- SUBJECT:** PUD-114
- APPLICANT:** Guy Houston, Valley Capital Realty
- PROPERTY OWNER:** Pleasant View Church of Christ
- PURPOSE:** Application for: (1) Rezoning from the A (Agriculture) District to the PUD-RDR/A-OS (Planned Unit Development – Rural Density Residential/Agriculture and Open Space) District; and (2) Planned Unit Development (PUD) Development Plan to allow for the construction of three new single-family residences and three second units on the property.

- LOCATION:** 11300 Dublin Canyon Road
- GENERAL PLAN:** Rural Density Residential
- ZONING:** A (Agriculture) District
- EXHIBITS:**
- A. [Draft Conditions of Approval](#)

Figure 4: Yard Determinations

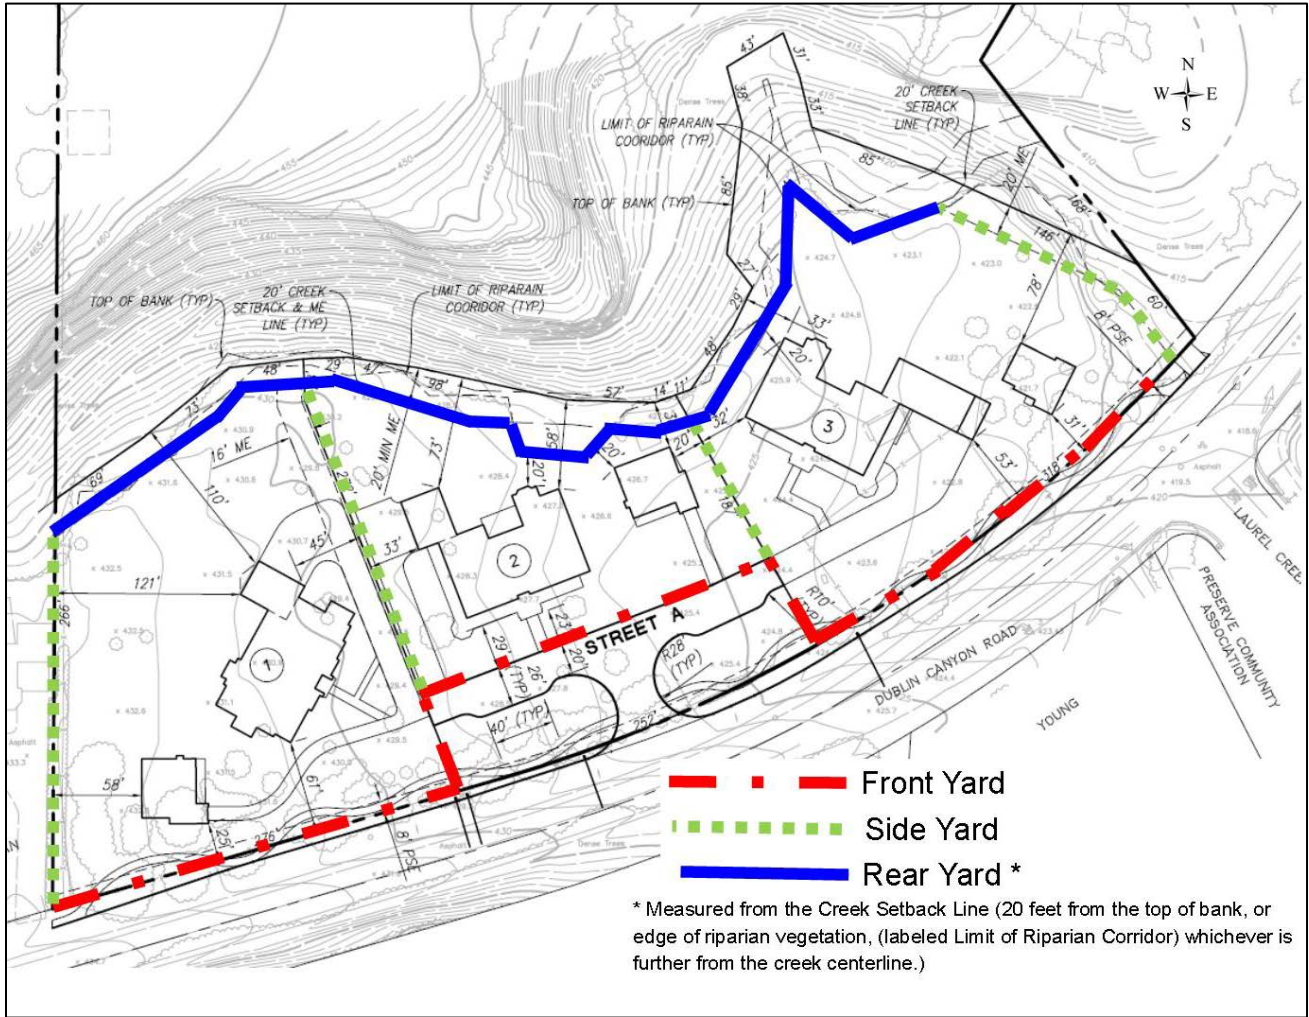
Setbacks. Staff believes that proposed setbacks are acceptable as they would provide appropriate distance between the proposed property lines and homes and are consistent with setbacks established within the Preserve and Kolb Ranch developments. Figure 4 provides the location where all setbacks are to be measured from. Front yard areas would be measured from the back of the private street or property line, as shown in Figure 4. Rear yard setbacks will be measured from the Creek Setback Line identified in Figure 4. The Creek Setback Line is measured from 20 feet of the top of bank or the edge of riparian vegetation (labeled Limit of

Riparian Corridor on plans), whichever is further from the creek centerline. The second unit setbacks will also be measured from the Creek Setback Line and are consistent with the R-1-20,000 Zoning District requirements with the Pleasanton Municipal Code

² Although the current application shows a proposed 13 ft. setback, the project has been conditioned to be revised to include a minimum 20 ft. setback.
